Chapter 1. Target Devices

Chapter 4. Changes

This chapter describes change from V2.00.00 to V2.00.01

4.1.6 Control correction of a competition pin

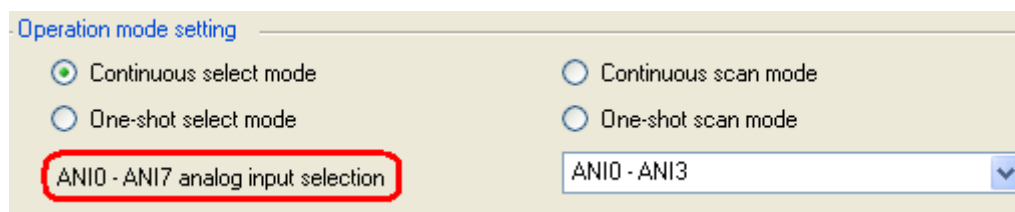
Control of the competition pin when simple-I2C of 24 and 25 pin device of RL78/G13 is set up was corrected.

Before : P17/SDA11

P30/SCL11

After : P50/SDA11

P30/SCL11

This issue has been corrected in Code Generator for RL78,78K0R,78K0 V1.00.03

4.1.15 Changes of Simplified I2C

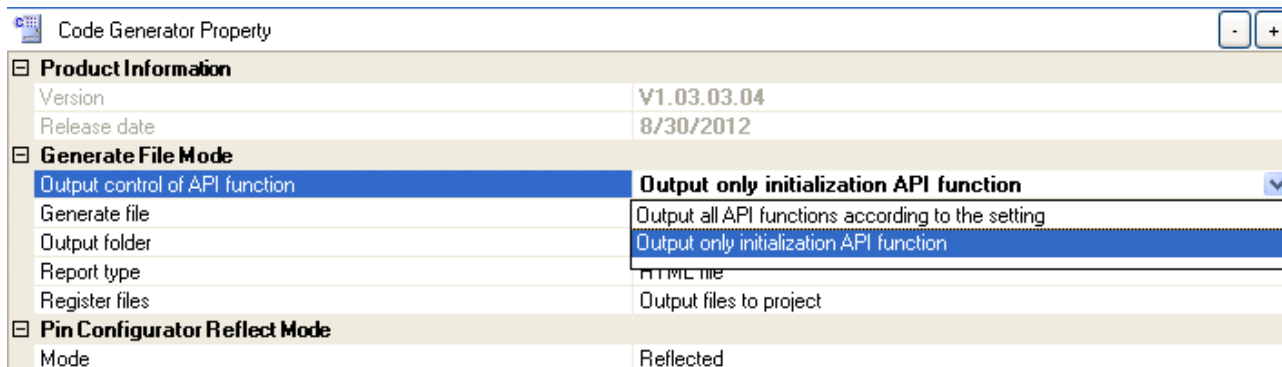
I When a receiving byte is set to 1 by Simplified I2C, it does not operate normally.

This issue has been corrected in Code Generator for RL78,78K0R,78K0 V1.00.06

4.1.22 Changes the notation of a power supply

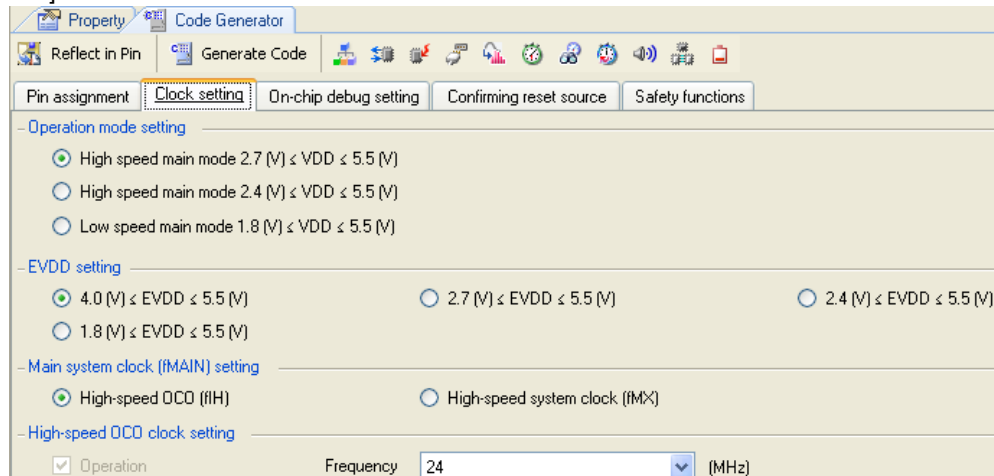
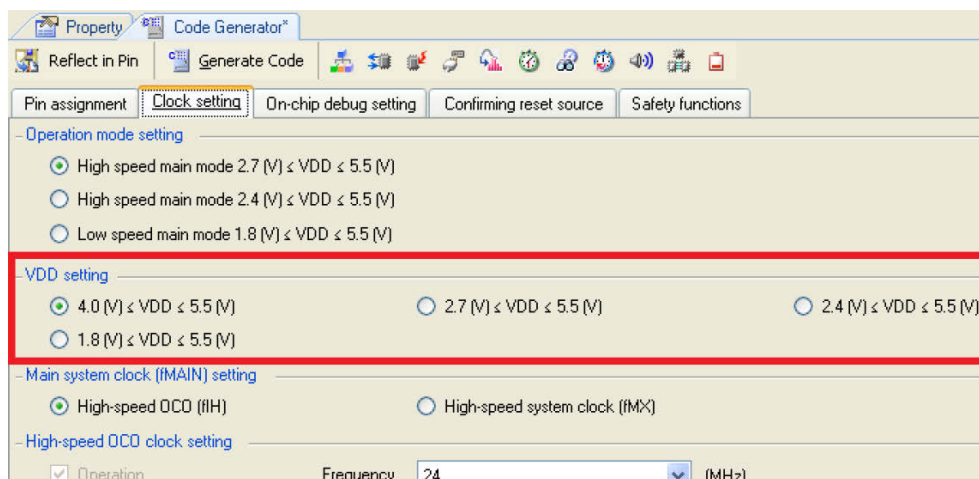
Although there was not EVDD in RL78/G12 device, it corrected that the notation remained on GUI.

This issue has been corrected in Code Generator for RL78,78K0R,78K0 V2.00.00.

5.2.8 Cautions of a setup of a real-time clock

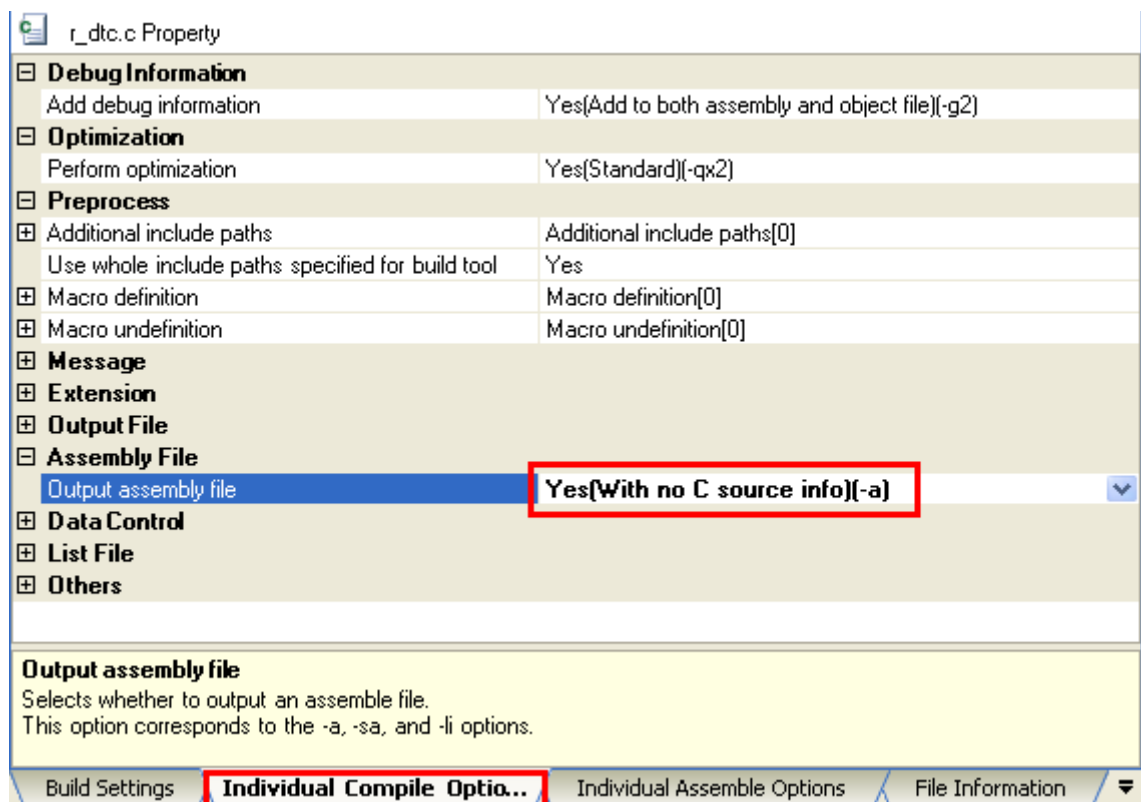
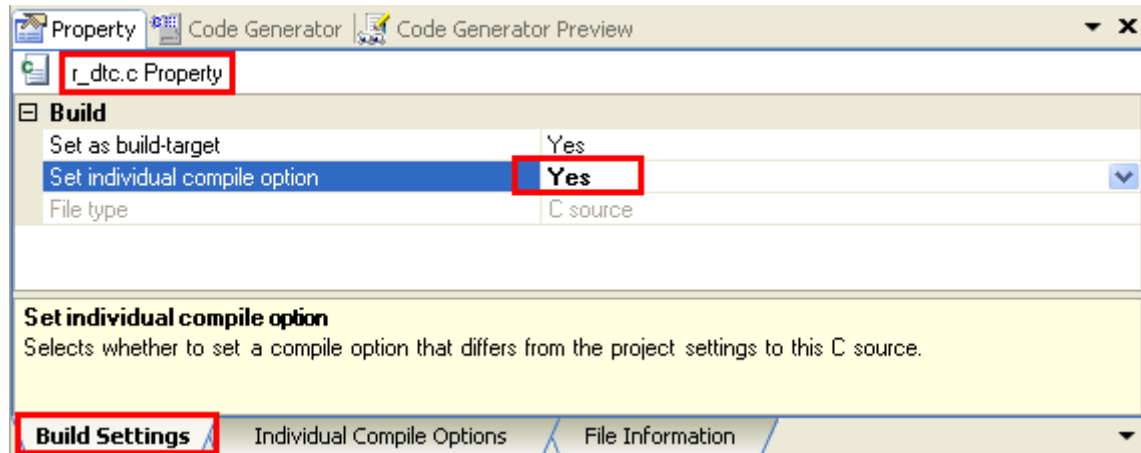
When a clock sauce is set to 15(fIL)kHz on device, clock function cannot be used. However, it is displayed on GUI that clock function seems to be used with 15(fIL)kHz. Please do not set up clock function.

[Workaround] There is no workaround

5.2.15 Cautions of Safety Functions

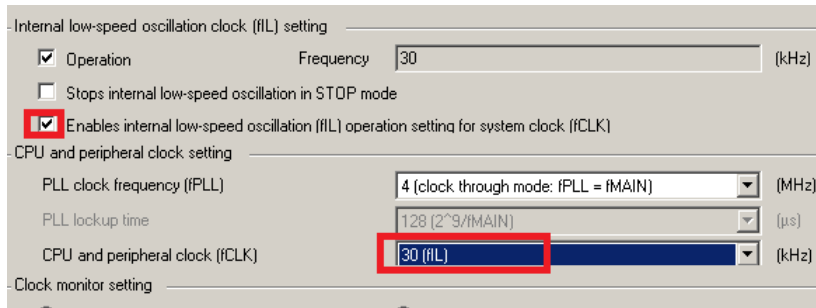
RAM parity error detection function of Safety Functions has not corresponded.

[Workaround] There is no workaround.

a) Clock

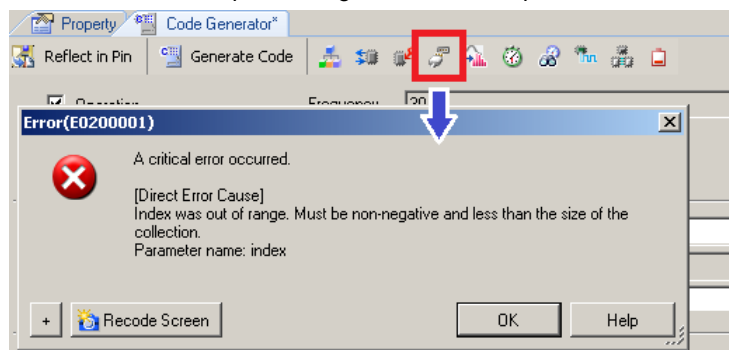
- Check in the two following items.

- Selection of a serial panel will generate an exception.

RL78 Code Generator is corrected in V2.00.01

b) Timer and serial

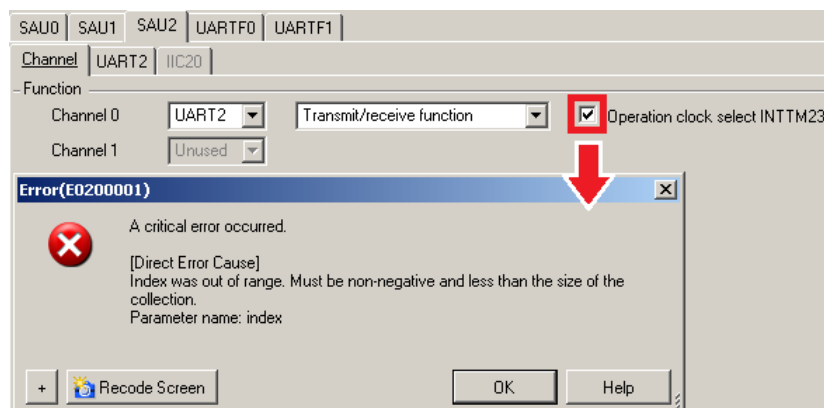
- Use interruption for the channel 3 of timer TAU2 in a certain mode.
- If a clock of operation checks one serial of serial SAU0, SAU1, and SAU2 "Operation clock select INTTM23", an exception will occur.
